## **Harbor Area Review Board Staff Report**

**From:** Rob Testerman  
**Date:** December 20, 2013  
**Item:** The Shanty  
**Attachments:** General and Detailed Application information.

The Shanty restaurant has applied for a review by the Harbor Area Review Board for modifications to the exterior of the building. The first proposed modification is to extend, cover and enclose the front entrance.

ROOF PLAN  
1/4" = 1'-0"

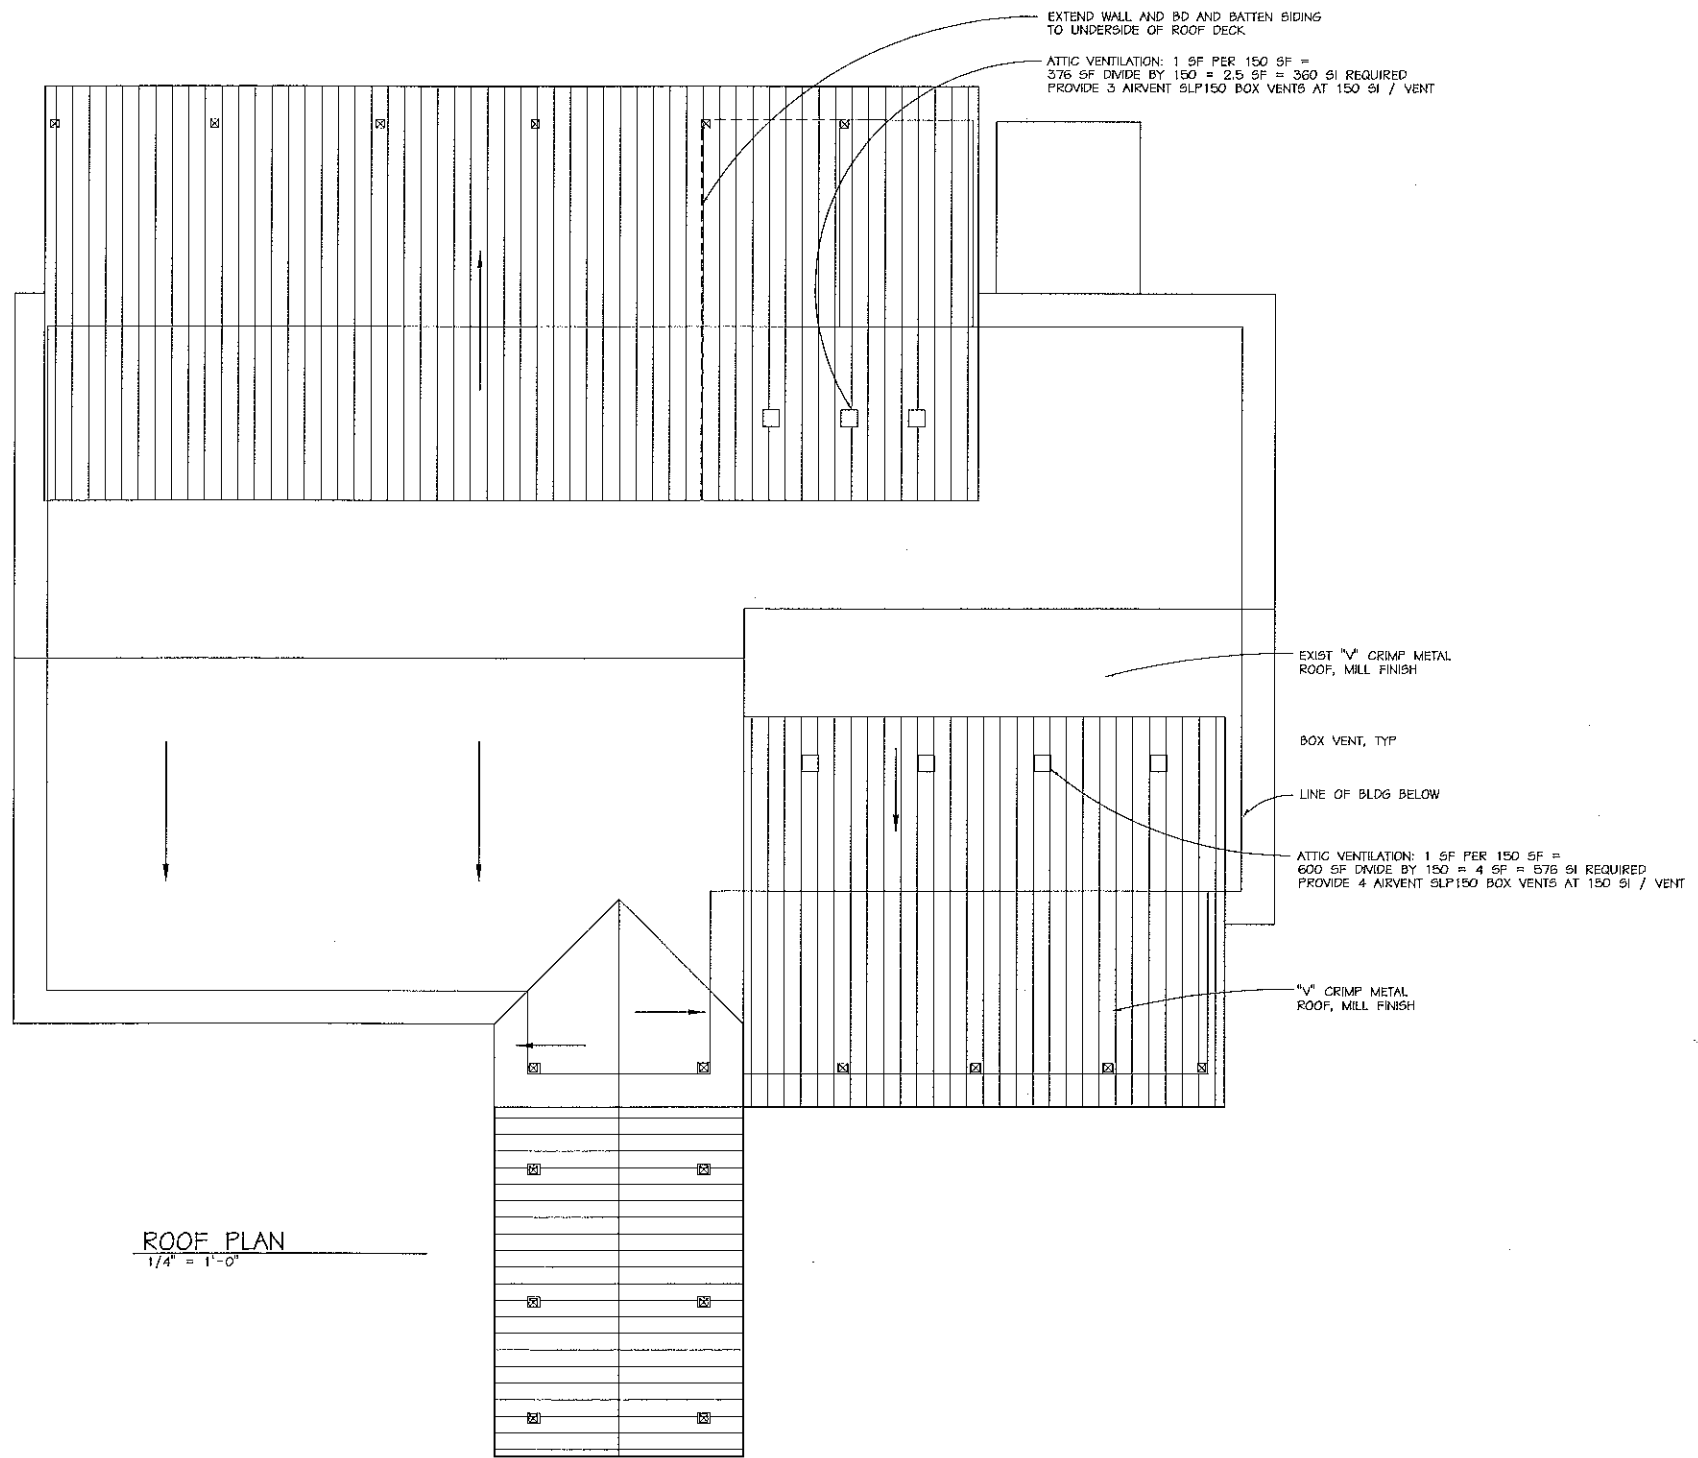
- The roof of the extended area will be 26 gauge metal roof to match the existing roof. The roof proposed over the front entrance will be 6:12, matching the existing pitch at the front door, and consistent with the guidelines.
- The additional area will use vinyl windows to match existing windows.
- The existing railing system will be extended to match the existing railing.
- Board & batten vertical siding will be used on the exterior walls.

- Like the proposed entrance expansion, the new roof will be 26 gauge metal roof, matching the existing roof. The proposed roof pitch for this section is 3:12. The guidelines state that secondary metal roofs may have slopes less than 6:12.
- Vinyl windows to match existing will be used.
- Board & batten vertical siding is proposed for the exterior walls.

- 26 gauge metal roof is proposed for covering the deck area, matching the existing roof. The proposed pitch of the roof over the back deck is 3:12, again, as this is a secondary roof, the proposed pitch is acceptable.
- The cover will be supported by treated 6x6 posts.
